UNITED STATES
DEPARTMENT OF THE INTERIOR
BUREAU OF LAND MANAGEMENT

SUNDRY NOTICES AND REPORTS ON WELLS
Do not use this form for proposals to drill or to re-enter an abandoned well. Use Form 3160-3 (APD) for such proposals.

Many Canyon 29-04-26 #33

This well was originally permitted and approved as a vertical PC well on 8/15/2006. A sundry with a new drilling plan changing the un-drilled well to a dual horizontal PC well was approved on 12/12/2006. This revised drilling plan based on recent drilling data will modify the drilling angle.

VERTICAL SECTION (Ft) @ 97.27°

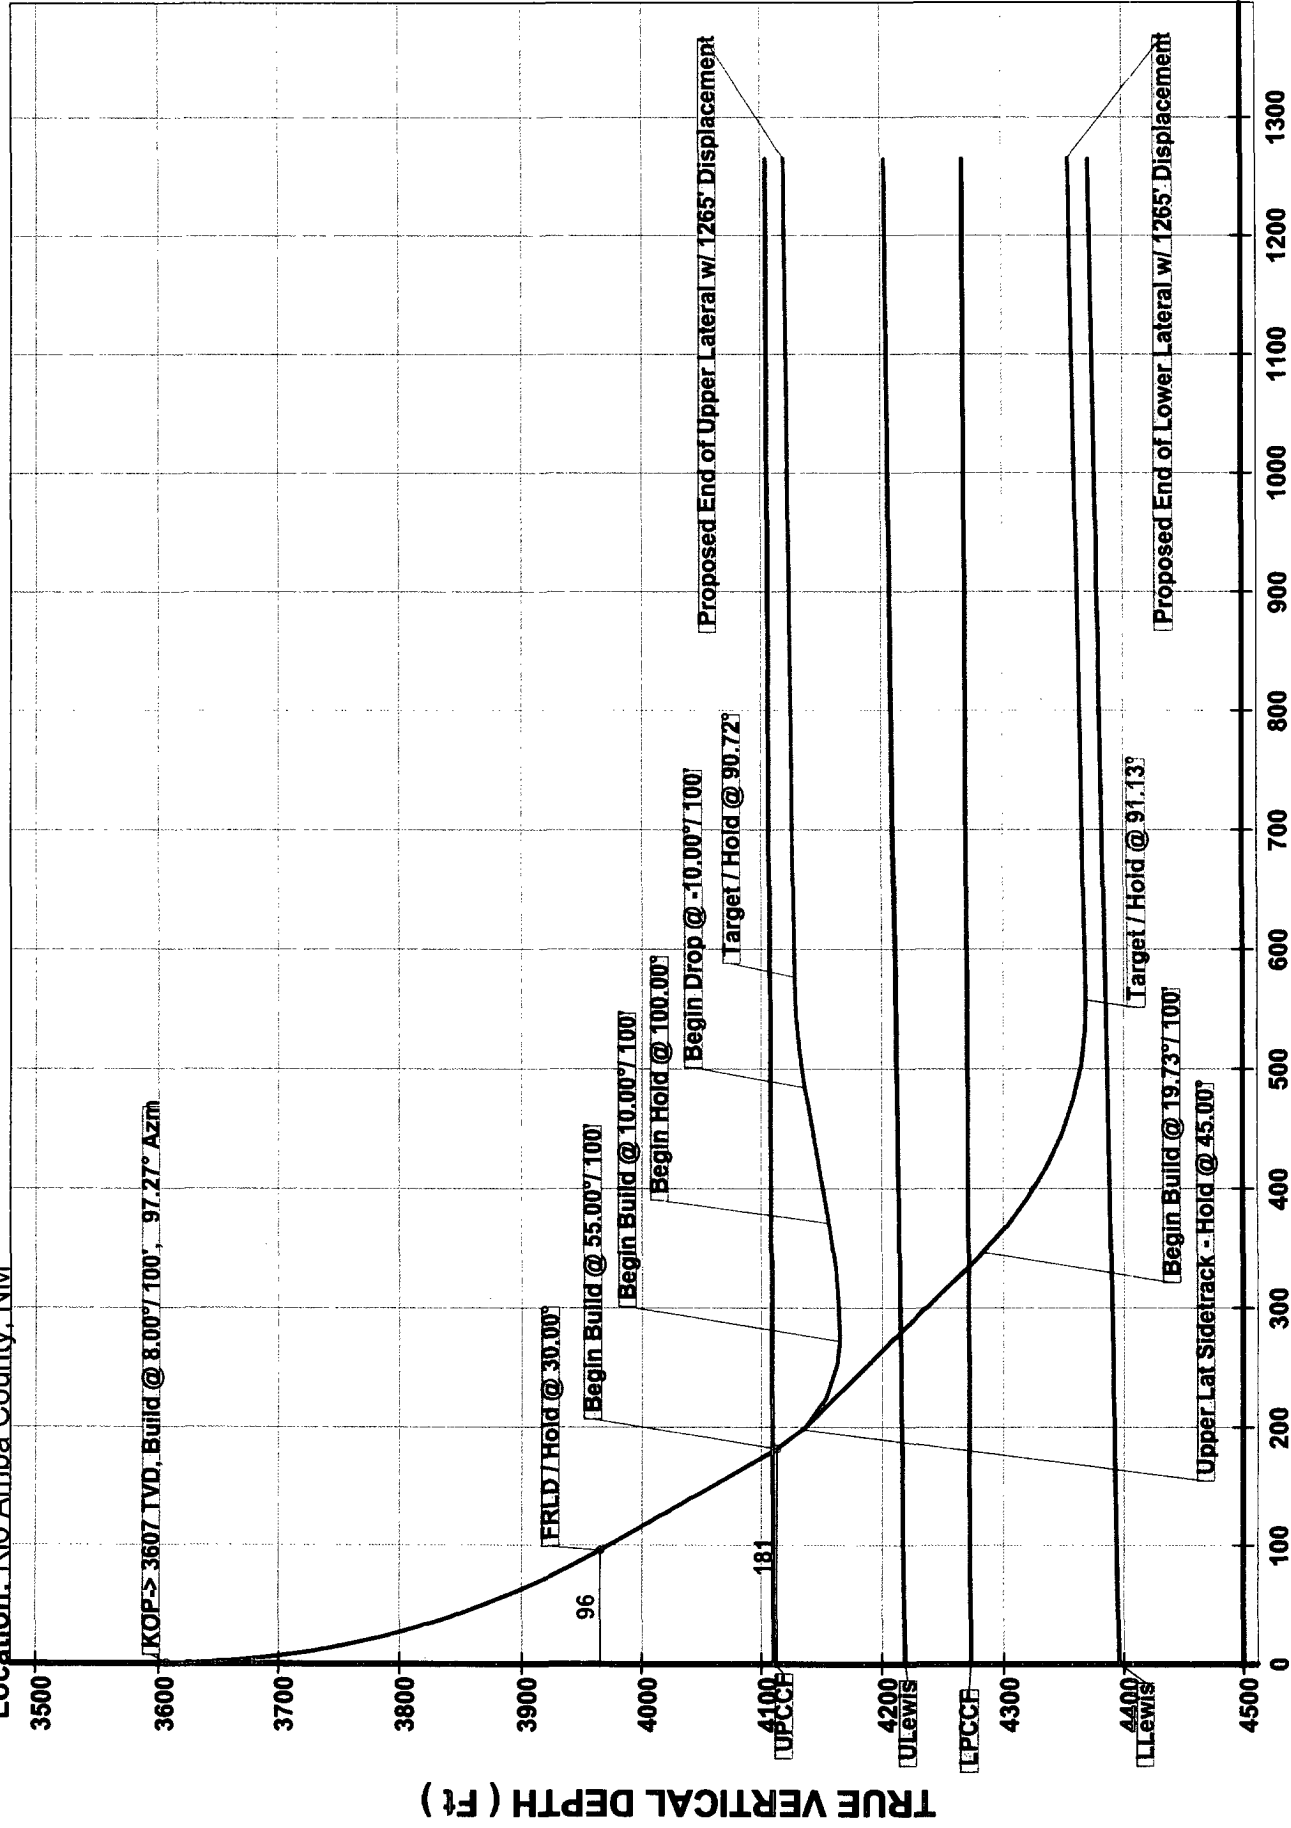
The initial APD to drill a Pictured Cliff (PC) well was approved on 8/15/06. The well was given API # 30-039-29988. BHGR submitted a sundry to convert the vertical well to a horizontal well, which was approved 12/12/2006. This sundry modifies the drilling angle based on recent drilling data. BHGR requests that if tests of the tertiary and PC formations are favorable that BHGR will complete these formations and submit comingle applications.

Surface disturbance will not change from the initial APD, therefore the Surface Use Plan will not be updated or modified. Attached is the revised drilling plan and the Nevis drilling data.

HORIZONTAL DRILLING PROGRAMKick Off Point is estimated to be \pm 3607' TVD**CASING PROGRAM**

| Depth | Hole Diameter | Casing Diameter | Casing Weight and Grade | Cement |
|--|---------------|-----------------|-------------------------|--|
| 3607' TVD (KOP) End of Lateral Bore | 4-3/4" | 2-7/8" | PH-6 Liner | None |
